State Significant Development Application
Response to Submissions

SSD-80904224 In-fill Affordable Housing
93 Bridge Road, Westmead

Prepared for 93 Bridge Road Pty Ltd atf Bridge Road Unit Trust

Figure 3 DCP and PP envelope overlay

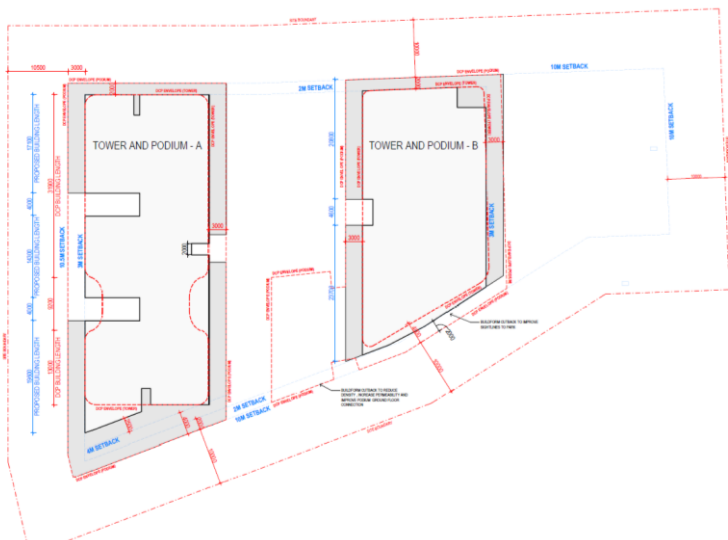
Council and the Department identified several inconsistencies between the site-specific DCP prepared for the concurrent Planning Proposal (PP-2023-2810) and the proposed SSDA. In their key issues letters, the Department requested that *the SSDA must be co-ordinated with the PP, and either the proposal or the draft DCP controls must be revised to ensure they are aligned in terms of:*

Group GSA has prepared an overlay outlining where variations to the envelope established by the Planning Proposal are proposed, as shown in

Figure 3. This figure demonstrates the minor nature of the variations proposed, these variations are described in detail in **Table 5.**

Figure 6 Section Plan

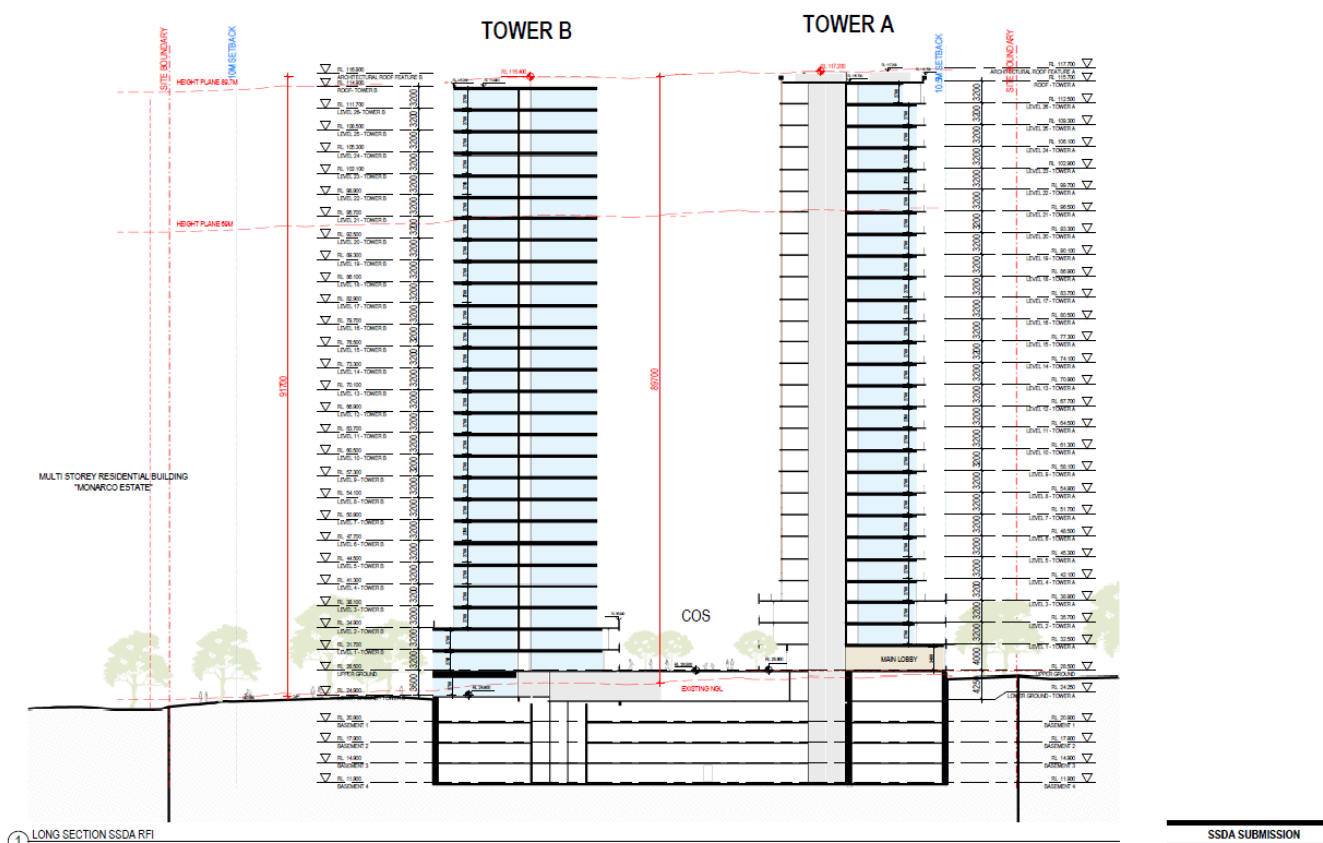
Community members suggested that the proposed building height of the development is excessive when considered against the current planning controls, and that the proposal would undermine the objectives of the area.

The proposal is consistent with the statutory framework that applies to the site and does not exceed the development potential contemplated by the planning system. The project is underpinned by Planning Proposal PP-2023-2810, which seeks to amend the *Parramatta Local Environmental Plan 2023* to apply a maximum building height of 69 metres and a maximum FSR of 3.6:1. The SSDA is contingent on the finalisation of this Planning Proposal, meaning that the proposal cannot be approved without those new controls being in place. It is understood that as of January 2026 that the Planning Proposal is being finalised.

In addition, the development lawfully utilises the in-fill affordable housing bonus provisions of the Housing SEPP, which provide a 30% increase in building height and FSR where at least 15% of total GFA is delivered as affordable housing for a minimum period of 15 years. The proposal overlaid with the maximum height control of the LEP and the bonus afforded by the Housing SEPP is provided as **Figure 6**.

Figure 8 Cross ventilation diagrams

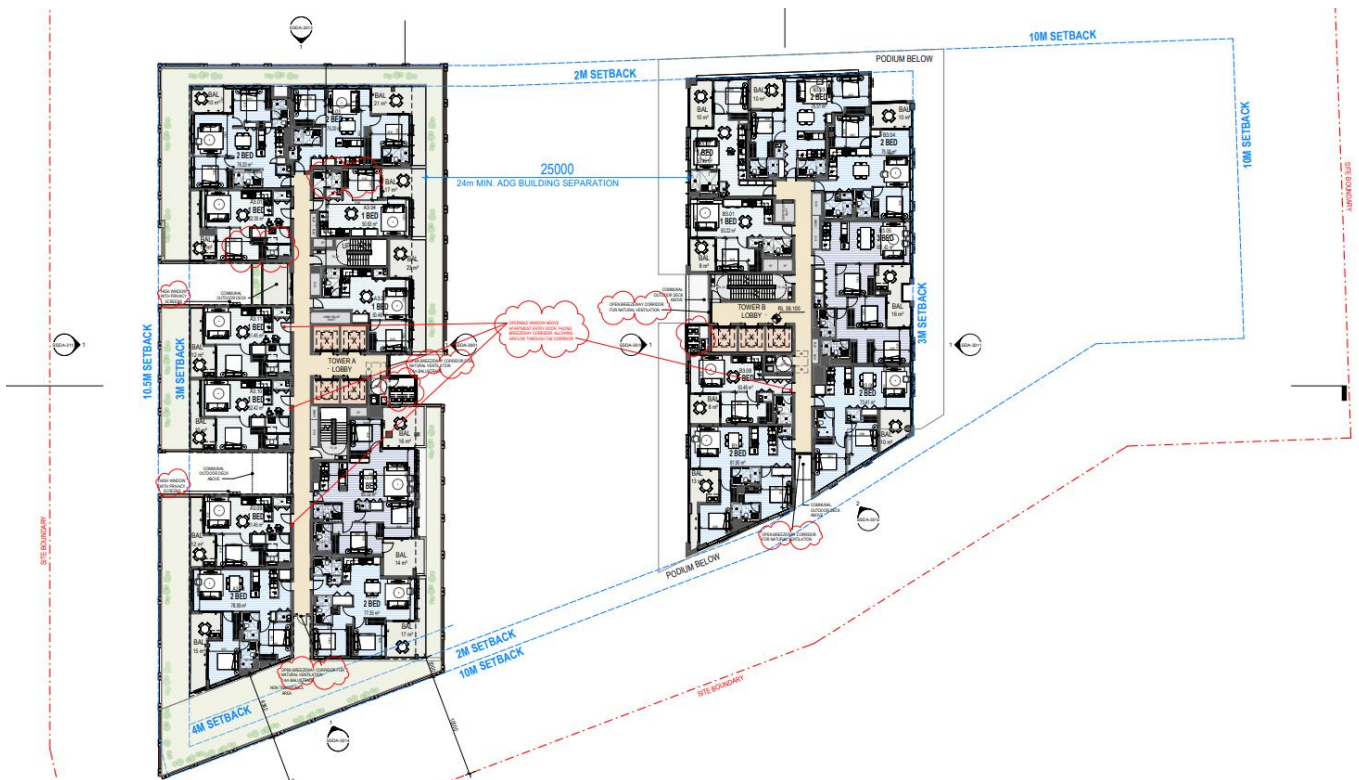
The Department identified that several apartments marked as naturally ventilated (such as Units A7.01, A7.06, A7.09, A7.10, A7.11, and B7.080) do not appear to receive adequate natural ventilation as these units rely on windows that face articulation zones or similar areas which may limit airflow. The Department requested that wind testing be undertaken to verify that all apartments identified as naturally ventilated meet the ADG requirements.

In response to the Department’s concern with the natural ventilation of units that face articulation zones, the project team have amended the design of the development to include open corridors on the affected floors. RWDI have undertaken a qualitative assessment of the proposed design amendments which is documented in **Appendix J** and summarised below.

In RWDI’s opinion, the opening of the residential corridors on the affected floors, will reduce the effect of stagnation within building recesses when compared to enclosed corridors and increase the pressure differential between the openings on the windward aspect and the openings facing the notch. The proposed amendments will therefore promote natural cross ventilation via the concept of pressure differentials and therefore can allow these units to be naturally cross ventilated via pressure driven flow in accordance with the ADG in a similar manner to a corner or cross through unit. Group GSA have provided revised architectural plans confirming that the proposal will meet the 60% cross ventilation targets as:

- Tower A will provide 71/102 (69.6%) cross ventilated apartments
- Tower B will provide 47/71 (66.2%) cross ventilated apartments
